**Central Zoo Authority**

F. No. 21-2/2003-CZA(418)(Vol. IV)(NS) / 7901

DATE: 19.10.2015 <sup>Email</sup>

**Sub:- Amended Animal Collection Plan and Revised Layout Plan and Design for proposed construction of enclosures at Rajiv Gandhi Zoological Park and Wildlife Research Centre, Pune - Reg.**

SHEET TITLE : PUNE ZOO RUSTY SPOTTED CAT, LEOPARD CAT & JUNGLE CAT EXHIBIT SECTION B

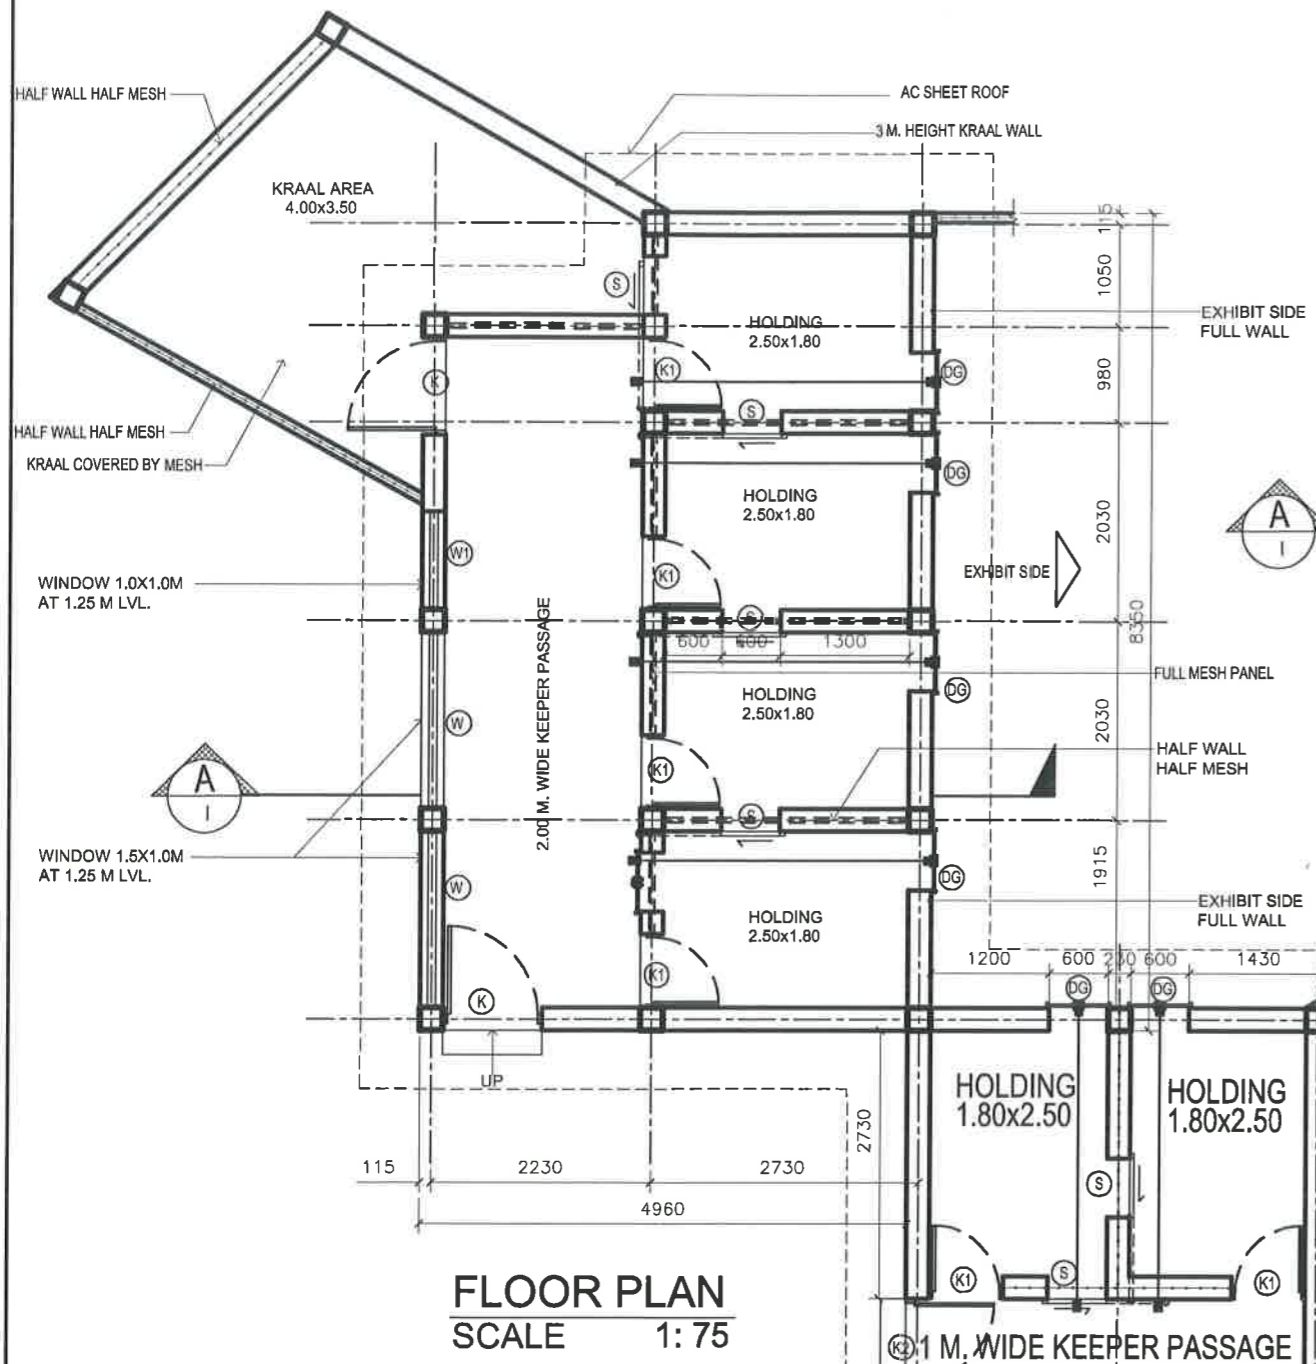
Members, on scrutiny of revised design for proposed construction of enclosure for Rusty spotted cat, Leopard cat and Jungle cat at Rajiv Gandhi Zoological Park and Wildlife Research Centre, Pune, found in compliance with suggested amendment and approved.
